Verification Report

006

GCL - Clarendon Road PHASE 3

AREA SURVEYED: Block D1 Slab - Pour 1. (2nd visit for this area).

VERIFICATION LAYOUT

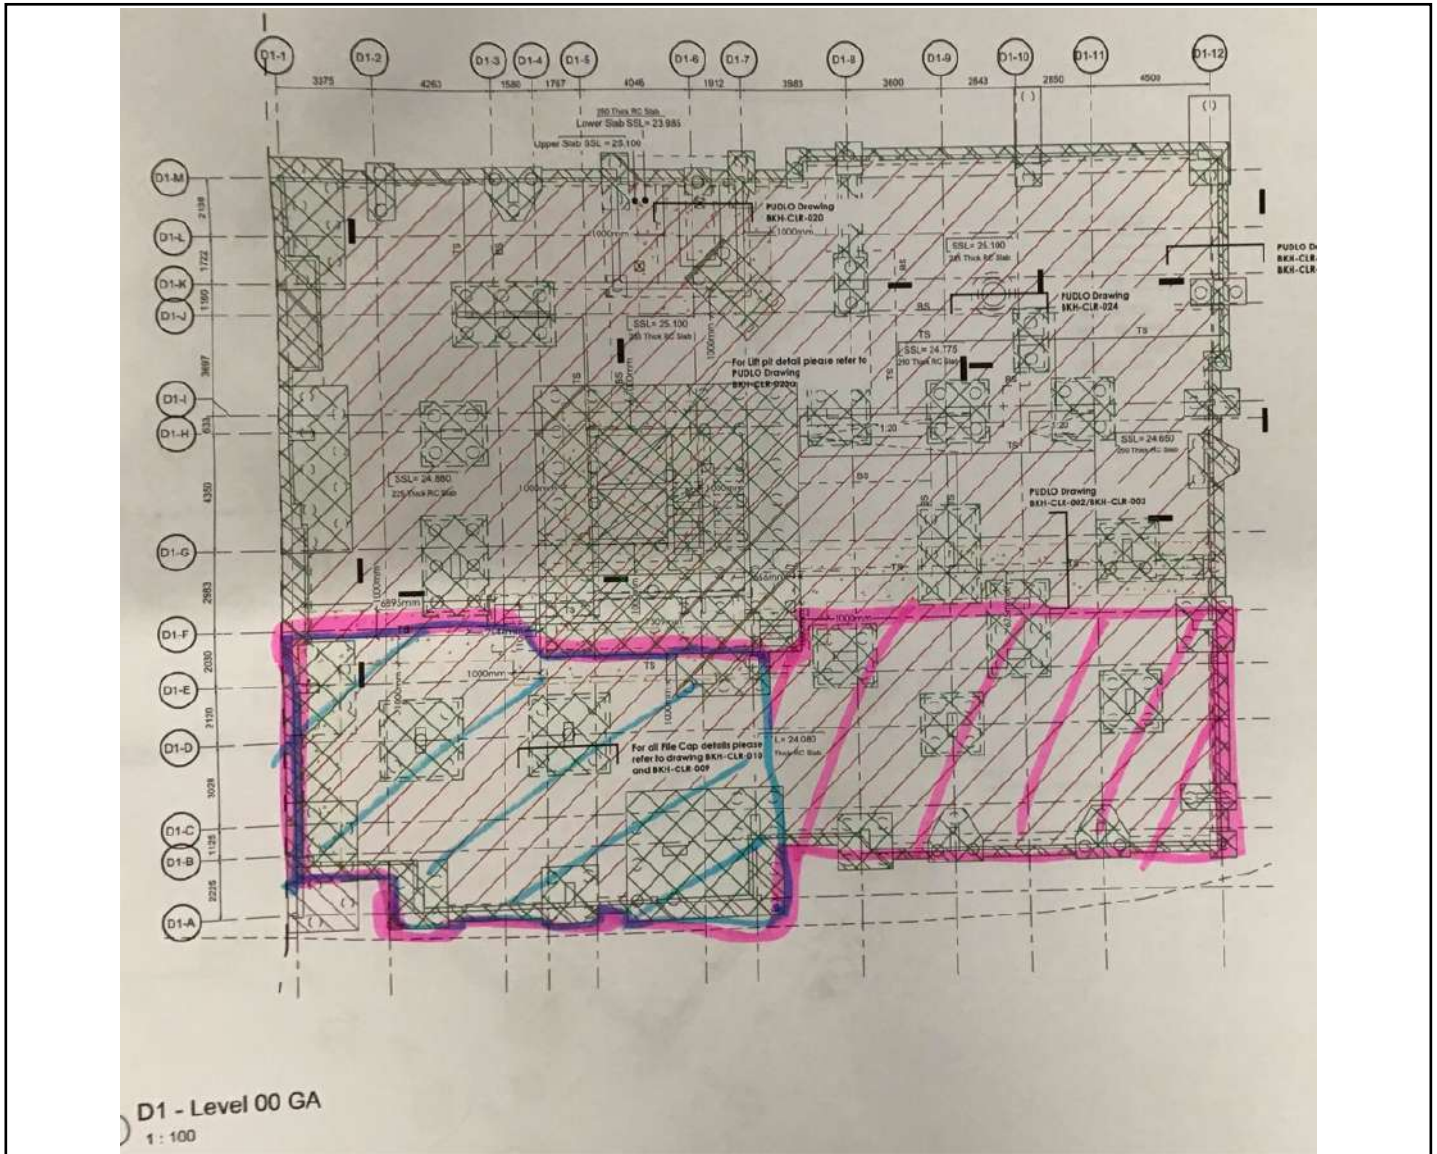
The layout above highlighted in pink shows Block D1 - Pour 1 (Base installation only)

This is the second time this area has been inspected due to the faults found previously

NOTES: Incomplete works - to be verified during next visit.

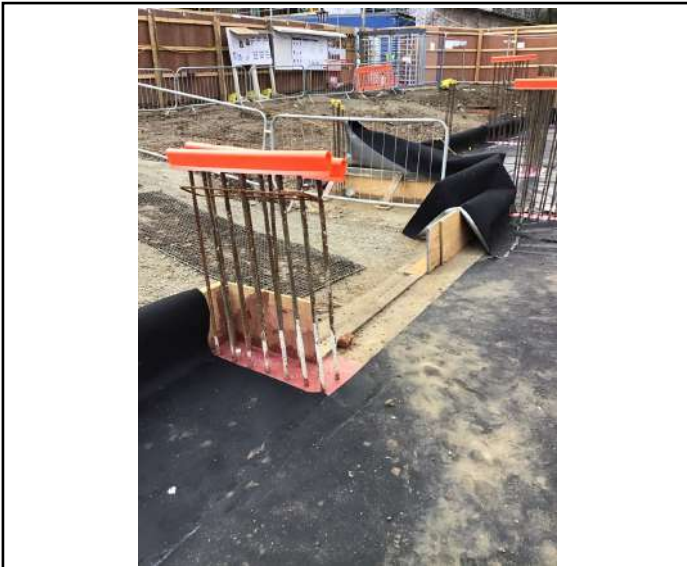
The two photographs below show examples of incomplete works, which haven't been possible to verify during today's visit. These works will need to be completed, and verified during the next visit, again to achieve sign off for this area.

The first photograph shows an access route for the area verified, the shutter will need to be erected, to allow the installers to lap and finish the membrane. The second photograph shows an incomplete pile cap, with a unsealed joint in the membrane.
